SEMICONDUCTOR MEMORY SYSTEM AND METHOD FRO MULTI-SECTOR ERASE OPERATION
Attorney Docket No. 4591-390/Application No. 10/822,167

Annotated Sheet Showing Changes

Fig. 2

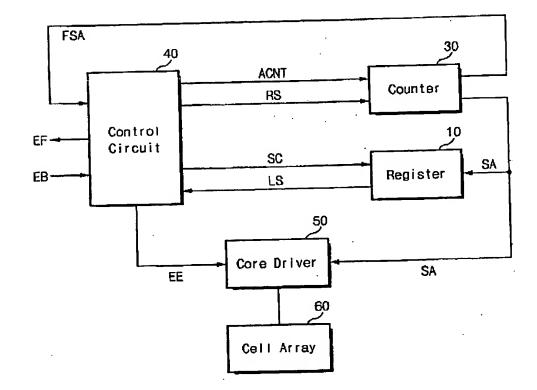
FIGS. 1-4 have been designated as PRIOR ART. Further, FIGS. 4 and 11 have had a typographic correction made to change the word 'initialiging' to 'initializing,' and 'initialige' to 'initialize.'

The drawings filed on 08 April 2004 were objected to by the Examiner, as FIGs. 1-4 should be designated as prior art. A proposed drawing amendment is including with this response. Formal drawings in accordance with these amendments will be sent when the drawing correction is approved. Approval of the proposed amendment is requested.

(PRIOR ART)
